DiPrete Engineering

RE: Comfort Inn and Suites
Gooding Avenue
AP 111 Lot 1
Bristol, Rhode Island
Project #: 2536-001-B01

On behalf of the applicant, D & M Boca Development, LLC, DiPrete Engineering respectfully submits the following response to correspondence received January 23, 2026 from the Planning Department, the correspondence as presented to the planning board public hearing made by Mr. Spinard.

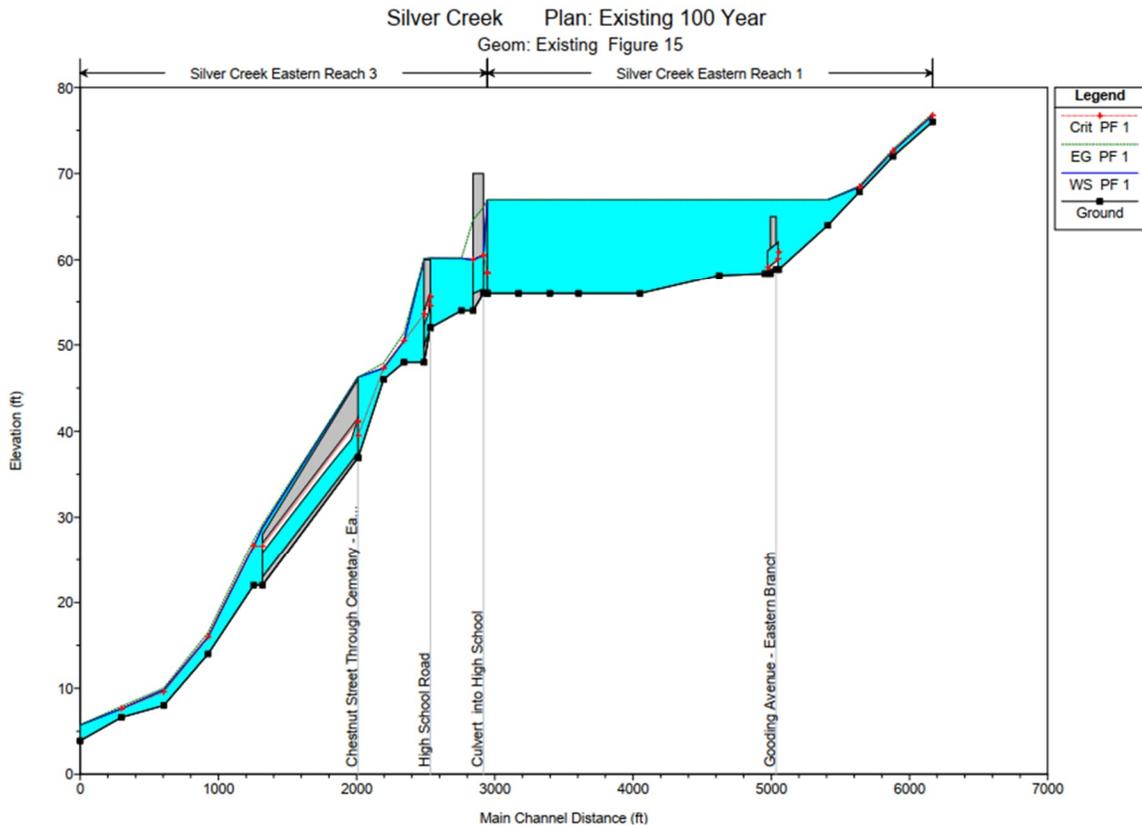
3. *The wrong method of analysis was used. The effect of flooding within the Silver Creek must be analyzed with HEC RAS given the irregularity of the channel and resultant irregular channel capacity.*

The flooding from the 100-year storm has been quantified with the HEC RAS analysis. A HEC RAS model has been analyzed by FEMA (2014) and by BETA Engineering (2007). Both methods had determined that the floodplain was caused as a continuous tail water elevation from the Mount Hope High School culverts backed up to the Gooding Avenue roadway. See following figure from this BETA watershed study:

The floodplain between the high school and Gooding Avenue behaves like a pond with constant elevation for the 100-year storm event. DiPrete Engineering considered the highest tail water elevation retained (elevation 67.0). A reduction of stormwater runoff rate and volume was designed to discharge to the Silver Creek tail water elevation. No alteration or filling of the Silver Creek tail water elevation is proposed; the minimum existing elevation onsite to be filled occurs near Sand Filter B and Headwall-19 between elevation 67.5 to 68.0.

Mr. Spinard's recommended modeling of the Silver Creek channel capacity would have no effect as the channel is under the tail water of the Mt Hope High School culverts. Mr. Spinard's opinion to model with HEC-RAS was not supported by the RIDEM staff engineers during permitting.
